ADDENDUM

Addendum: No. 2
Tender no: RFT-DRK-17-005-0
Date: June 6th, 2017
Re: Daycare Renovation at Kanata Public Elementary School

Addendum No. 1

Architectural Addendum No. 1

1 DAYCARE/PRESCHOOL DEMOLITION PLAN
 A101 SCALE 1:100

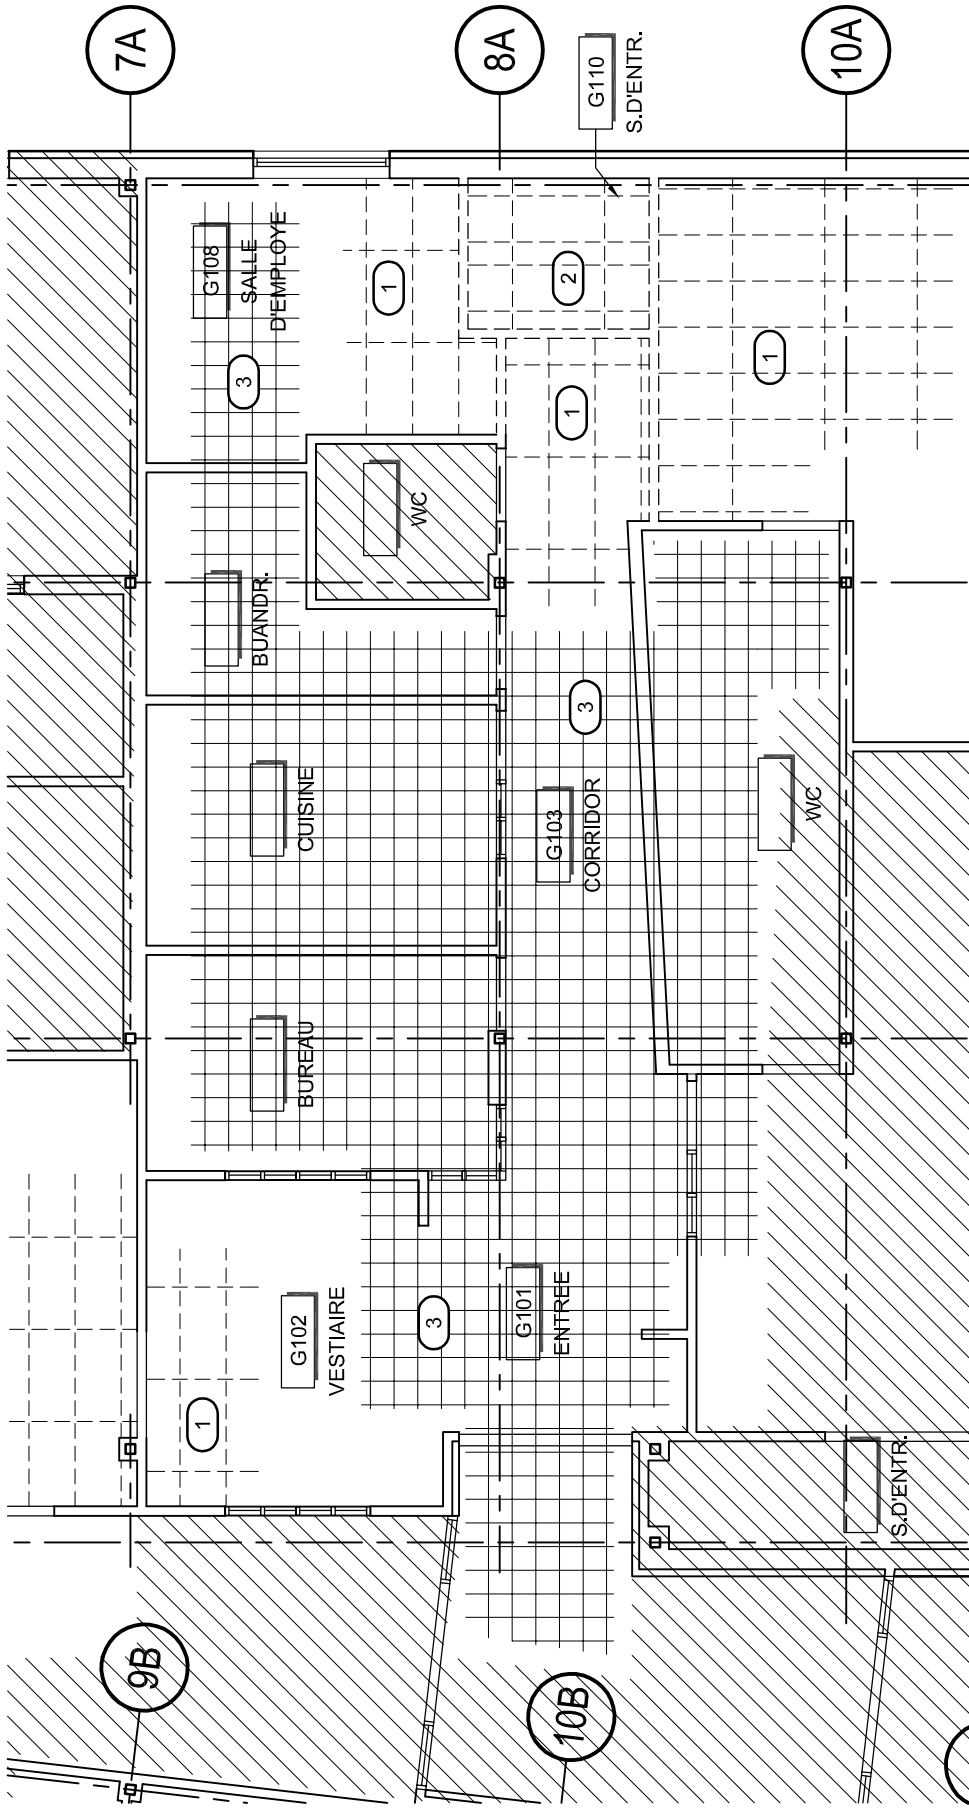
1. Detail 1/A101

1. **Extend** area of concrete slab sawcut for trenching. Refer to attached ASK-01.
2. **Revise** Specific Demolition Note #8. Refer to attached ASK-01.
3. **Add** Specific Demolition Notes #18, #19, and #20. Refer to attached ASK-01.

- (8) AREAS OF CONCRETE SLAB SAWCUT FOR TRENCHING. COORDINATE WITH MECHANICAL. SEE DETAIL 21/A104. REMOVE EXISTING VINYL FLOOR TILE AS REQUIRED. LEVEL REINSTATED SLAB AND PREP TO RECEIVE NEW FINISH. PROVIDE NEW VINYL FLOOR TILE TO MATCH EXISTING.

- (18) AREAS OF CONCRETE SLAB SAWCUT FOR TRENCHING. COORDINATE WITH MECHANICAL. SEE DETAIL 21/A104. REMOVE EXISTING MAT WHERE ADHERED TO FLOORING, AND STORE FOR REINSTALLATION. REMOVE EXISTING SHEET FLOORING TO NEAREST JOINT. LEVEL REINSTATED SLAB AND PREP TO RECEIVE NEW FINISH. PROVIDE NEW SHEET FLOORING TO MATCH EXISTING.

- (19) REMOVE EXISTING MOP SINK AND PROVIDE NEW MOP SINK. COORDINATE WITH, AND REFER TO, MECHANICAL. MAKE GOOD ADJACENT SURFACES DAMAGED BY DEMOLITION/ CONSTRUCTION.

- (20) REMOVE EXISTING COUNTERTOP SINK AND PROVIDE NEW COUNTERTOP SINK. COORDINATE WITH, AND REFER TO, MECHANICAL. MAKE GOOD ADJACENT SURFACES DAMAGED BY DEMOLITION/ CONSTRUCTION.

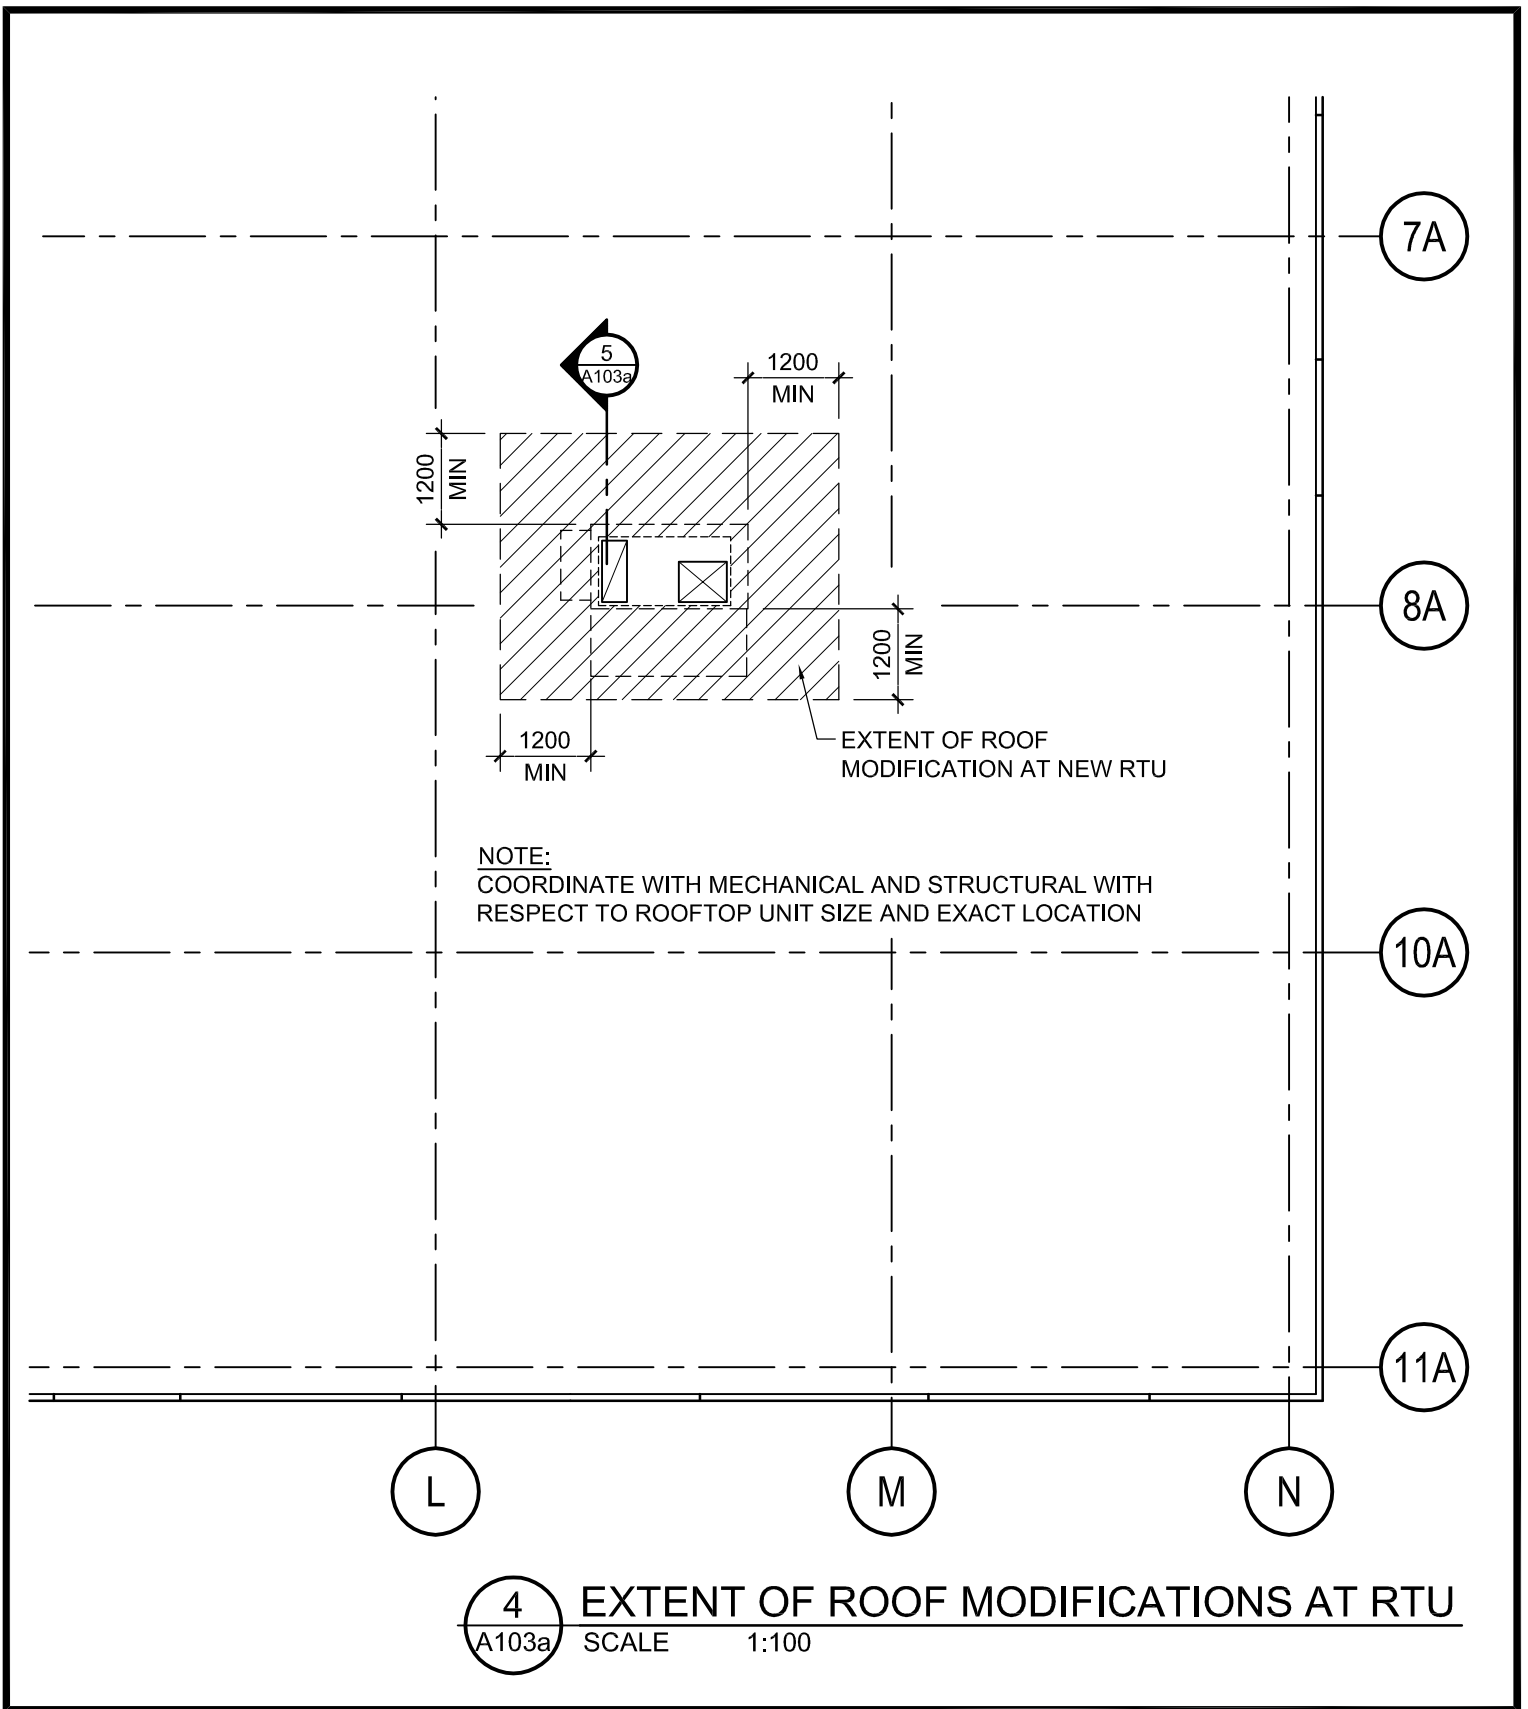
1. **Add** Roof Modifications at New RTU detail 4/A103a. Refer to attached ASK-03 and Structural Addendum #S1.
2. **Add** RTU Curb detail 5/A103a. Refer to attached ASK-04 and Structural Addendum #S1.
3. **Add** Exhaust Fan Curb detail 6/A103a. Refer to attached ASK-05 and Structural Addendum #S1.

NOTE: - COORDINATE WITH MECHANICAL AND STRUCTURAL WITH RESPECT TO ROOFTOP UNIT SIZE AND EXACT LOCATION.

- 1) REMOVE EXISTING ROOF MEMBRANE AND INSULATION, 1200mm ON ALL SIDES OF ENCLOSURE.
- 2) LAP AND SEAL VAPOUR BARRIER TO EXISTING ROOF VAPOUR BARRIER.
- 3) REINSTATE ROOF INSULATION AND PROTECTION BOARD.
- 4) LAP AND SEAL MOD. BIT. BASE & CAP SHEET MEMBRANE WITH EXISTING ROOF MOD. BIT. MEMBRANE.
